New Series 2 Aqua Plus Indirect-Fired Water Heaters

Dear Weil-McLain Distributors, Sales Representatives and Agents:

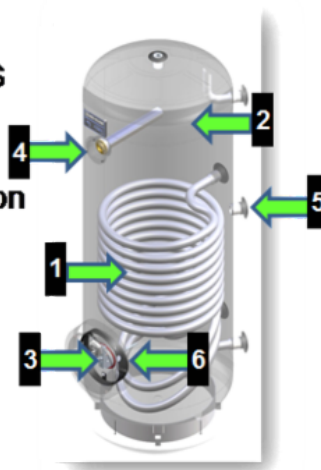
The changes between Series 1 and 2 are as follows:

- 1 Heat exchanger coil upgraded from 304 to 316L SS**
 - 2 Passivation process added to protect welds**
 - 3 Replaced existing thermostat with new digital version**
 - 4 Removed anode**
 - 5 Removed recirculation tapping**
 - 6 Removed inspection hatch**
- Changed jacket material**
